Groundwater Application Review Summary Form

Application # G- _17043, review_

PUBLIC INTEREST REVIEW FOR GROUNDWATER APPLICATIONS

SUBJECT: Application G- 17043   Supersedes review of _7/07/2008_

Figure 4a. Transient Stream Depletion

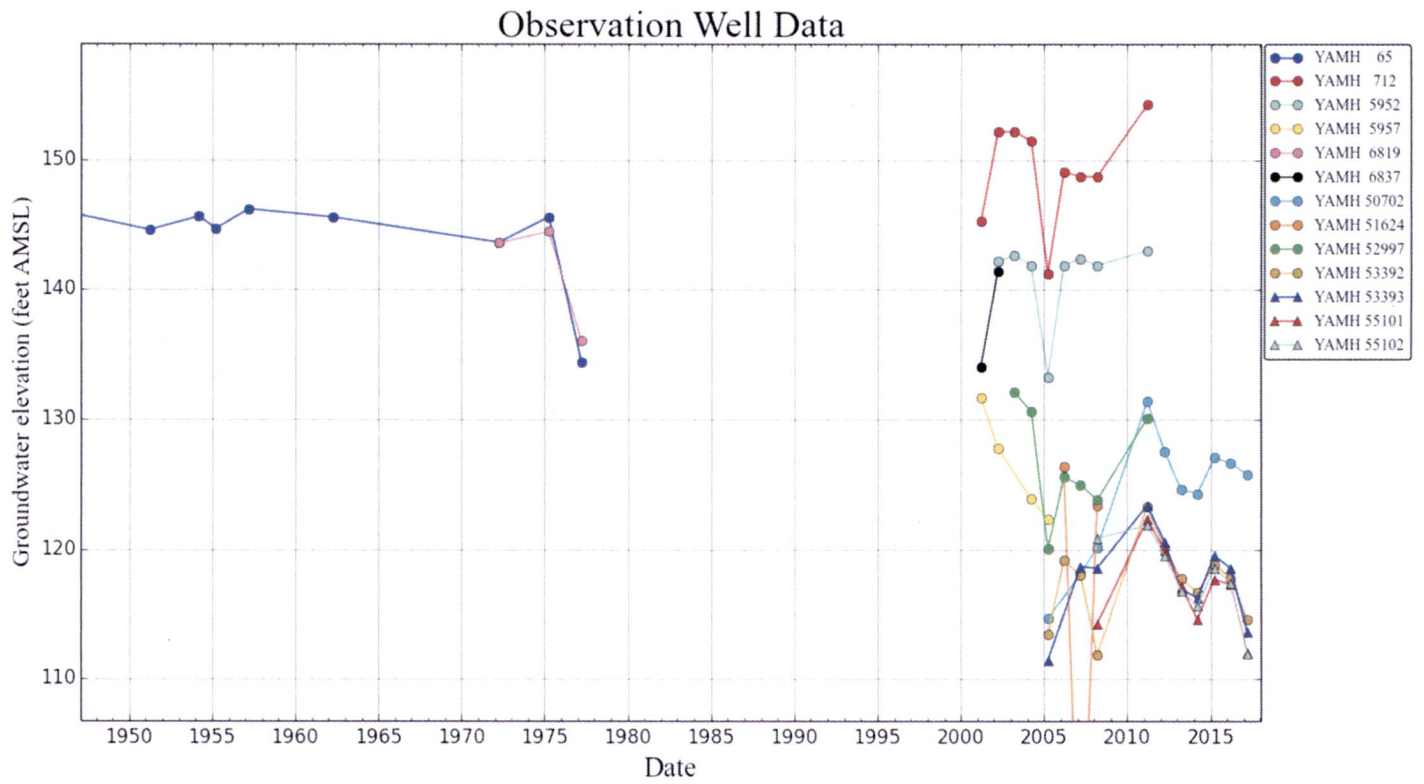
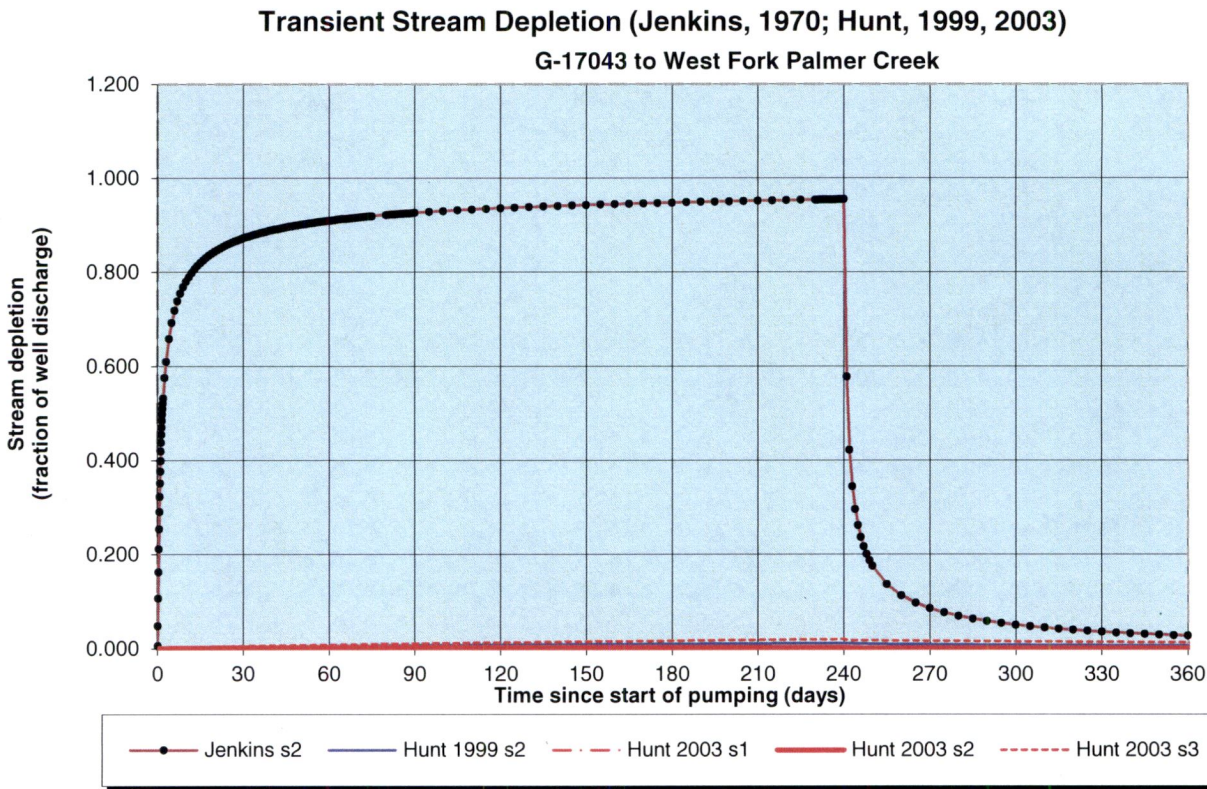
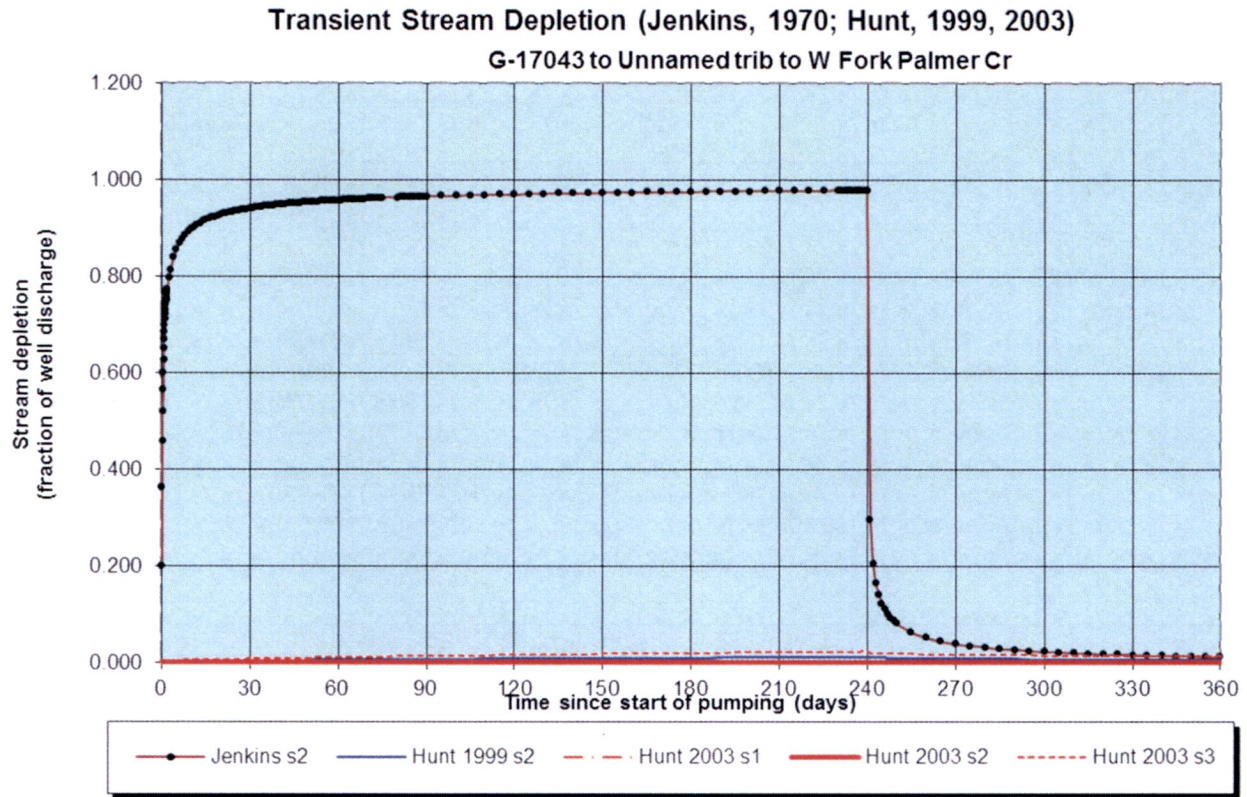
Comments: PSI is triggered by the proposed rate of 1.2 cfs, which is greater than 1% of the 80% exceedence natural flow of 56.50 cfs. Stream depletion is estimated using Hunt (2003), because that model incorporates the effects of low-permeability materials lying between a stream and an aquifer. The aquifer parameters utilized to estimate stream depletion represent the range reported for the Middle Sedimentary Unit (Conlon et al, 2005; Woodward and Gannett, 1998), all of which predict much less than 25% stream depletion at 30 days of pumping. See Figure 4 for analytical modeling parameters and results.
